Product / Process Change Notification

N° 2016-029-B !! UPDATE !!

Introduction of 5,0 mm Dome diameter for Econo3B platform and modification of the lid as precondition

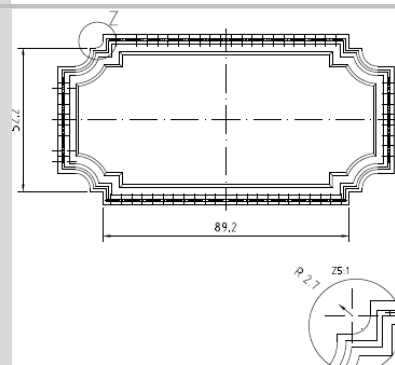
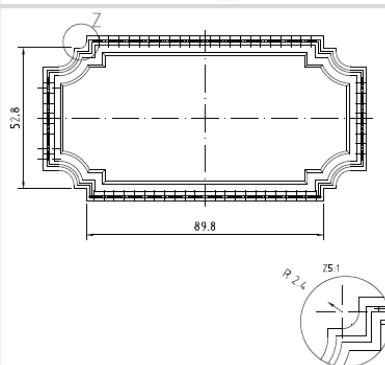
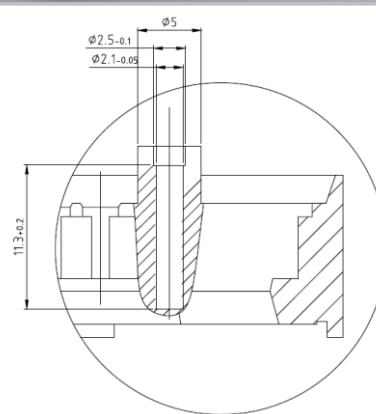
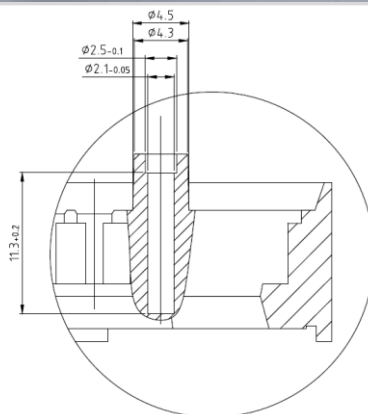
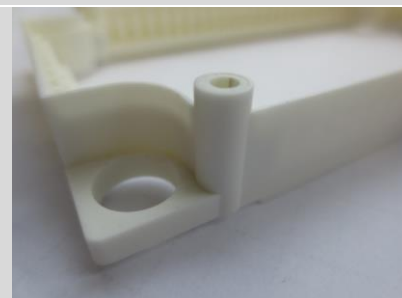
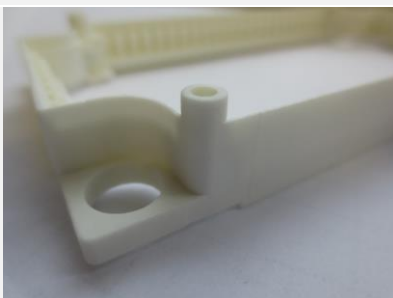
Subject: Increase of the outer diameter of the domes from 4,3mm to 5,0mm.

Reason: Harmonization of the Dome diameter

■ Outer diameter of the dome is 4,3 mm existing lid

■ Outer diameter of the dome is 5,0 mm new lid
